**Report: HVAC Findings for CFA 5073**

**Function: Test, Adjust, & Balance**

**08-14-23 CHICK-FIL-A #05073 - GRAND  
RAPIDS, MI (ALPINE AVE (MI) FSU) NEW  
STORE**

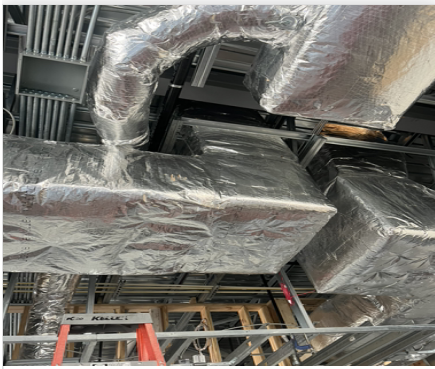
**Issue Name :** NON-CRITICAL: Hood 2 prepunch  
**Description :** Left side of hood 2 does not have screws securing it in the pre punched location.  
**Created By :** National TAB                      **Assigned To :** National TAB - Tyler Youells  
**Status :** Open  
**Originated Date :** 08/07/2023 - Gabe Merk - National TAB

Install screws

Turningvanereturn.jpe..  
06/20/2023

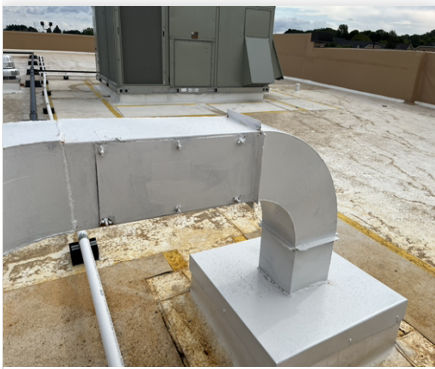
**Issue Name :** REVIEW + RECTIFY: Turning Vanes installed in AC Returns  
**Description :** Could not gain access but was informed turning vanes are installed in the returns of all AC units. Turning vanes are only to be installed in Supply ductwork. See M-901, 2.02, P.  
**Created By :** National TAB                      **Assigned To :** National TAB - Michael McDonnell  
**Status :** Open  
**Originated Date :** 06/20/2023 - Michael McDonnell - National TAB

- **08/07/2023**    **National TAB - Tyler Youells**
  - Turnings Vanes remain in the returns upon return TAB trip.

Leave them.

**Greaseductcleanout.jp..  
08/07/2023**

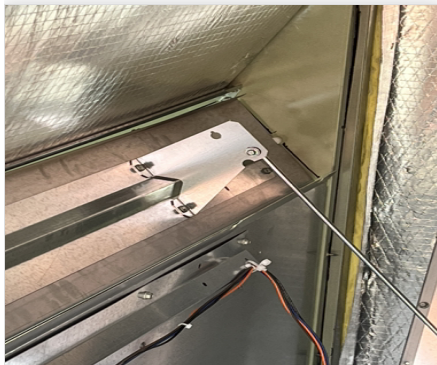
**Issue Name :** REVIEW AND RECTIFY: Grease duct clean out  
**Description :** Grease duct clean outs that are installed are incorrect. They are to have a 1 1/4" standoff flange. Downturn elbows are to have grease clean outs as well. See M250 Grease access door schedule. And Detail 1 for locations  
**Created By :** National TAB                      **Assigned To :** National TAB - Tyler Youells  
**Status :** Open  
**Originated Date :** 08/07/2023 - Gabe Merk - National TAB

**Install access ports for grease duct.**

**Incorrectexhaustgrill..**  
**08/09/2023**

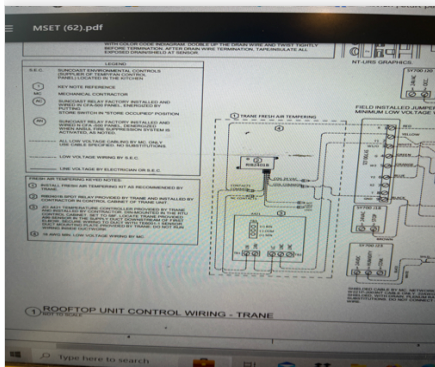
**Issue Name :** REVIEW+RECTIFY: Employee RR exhaust grille  
**Description :** The employee restroom exhaust Grille was installed as a 4-way supply when it is specified to be perforated type return. See M401 Air device schedule for proper Terminal device type.  
**Created By :** National TAB                      **Assigned To :** National TAB - Tyler Youells  
**Status :** Open  
**Originated Date :** 08/09/2023 - Tyler Youells - National TAB

replace supply diffuser with return grille from page 16.
